BULLETIN #2

DATE June 21, 2018

PROJECT NAME Saint Kenneth Catholic Church
Worship Space Addition & Renovation

PROJECT NUMBER 2014166

Sheet
S102

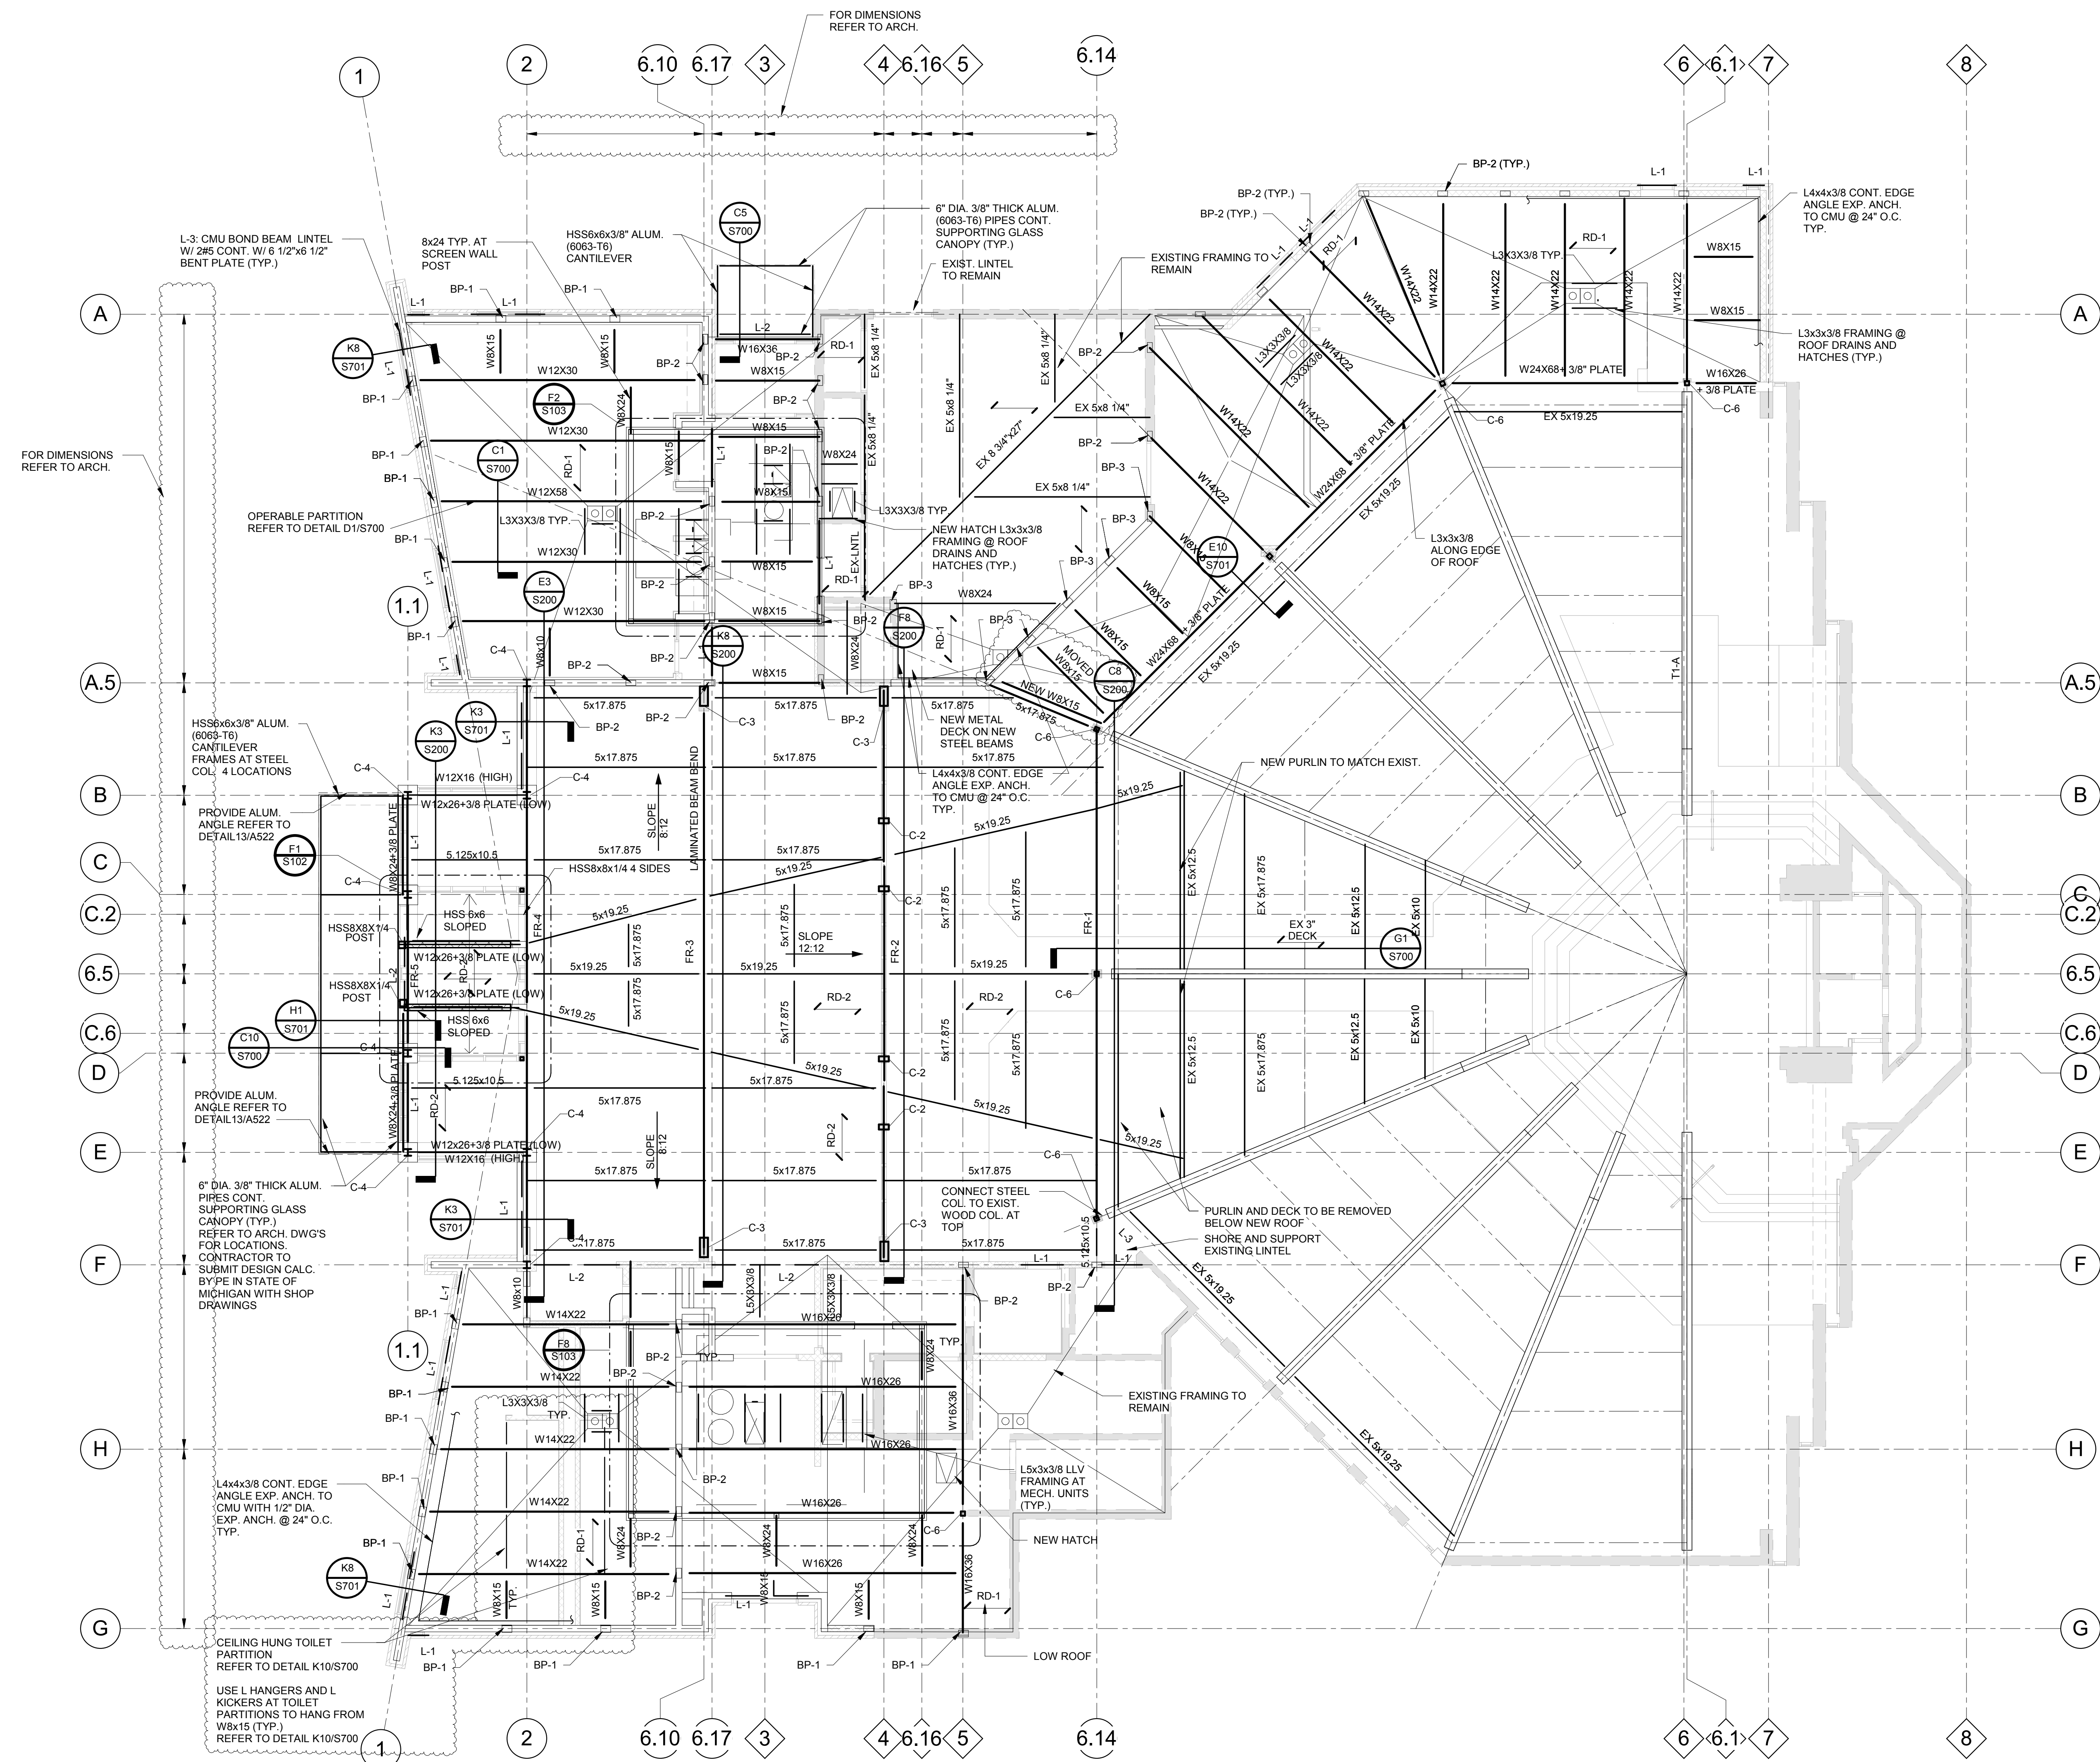
S102 Roof Framing Plan

- Added a beam W 8X15 from column line 5 to column line 6.14 between A.5 and B
- Moved a beam W 8X15 near column lines 5, 6.14, and A.5
- Added a note describing the miscellaneous steel to be used in conjunction with toilet partitions
- Added the following note regarding spacing between grid lines "For Dimensions See Arch."

K10 DETAIL AT PARTITION
S700 3/4" = 1'-0"

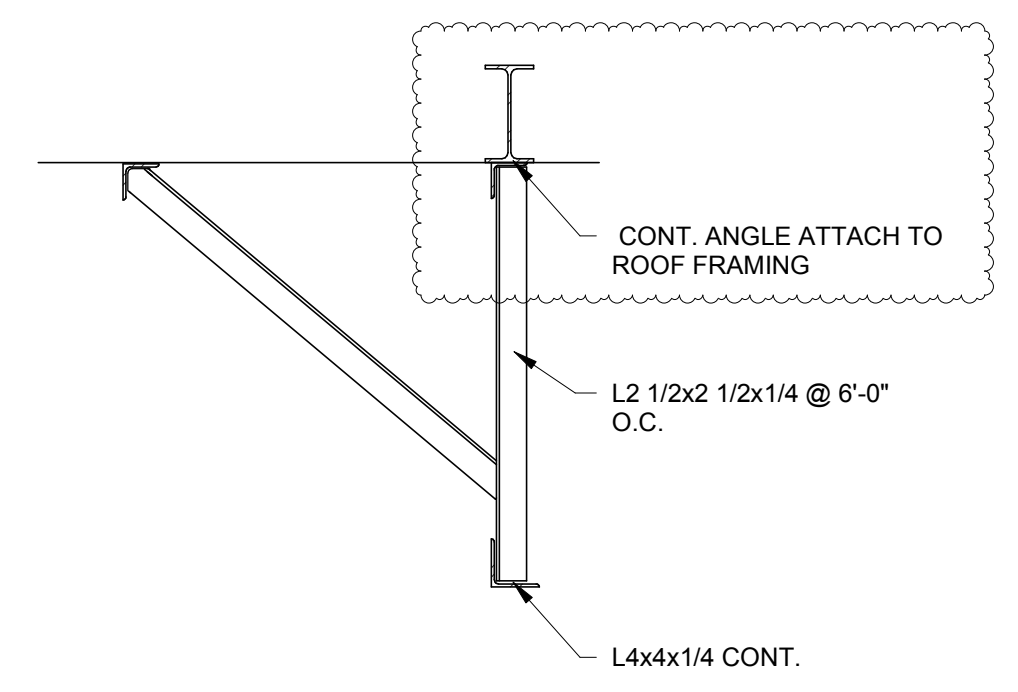
S700 General Sections and Details

- Modified section K10/S700 to show W8x15 beam
